Access Compliance Report Public Rights-of-Way (Curb Ramps)

Main Street: SIENNA_PKWY		Cross Street: WINDMILL_AVE		Location:	S
ADA ID: RPRK211109115657	Ramp Type: Type 1 - Perpendicular	Initial Pass/Fail: Fail	Overall Compliance: No	Severity Score:	32

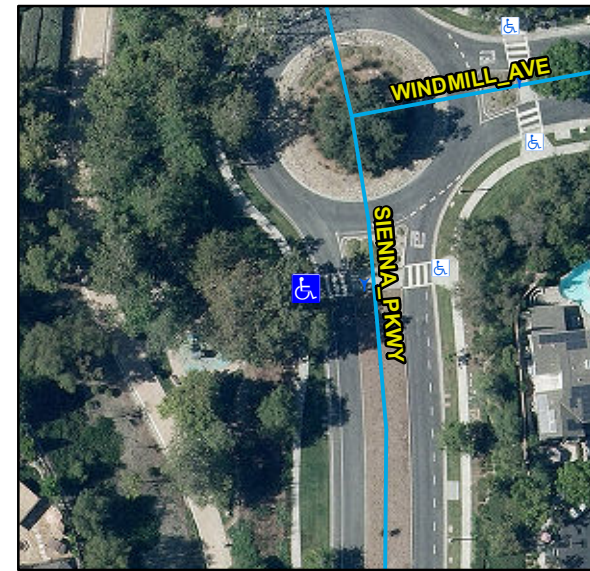
R304.2.2, R204.3, STD 1115

Remove & Replace Entire Ramp.
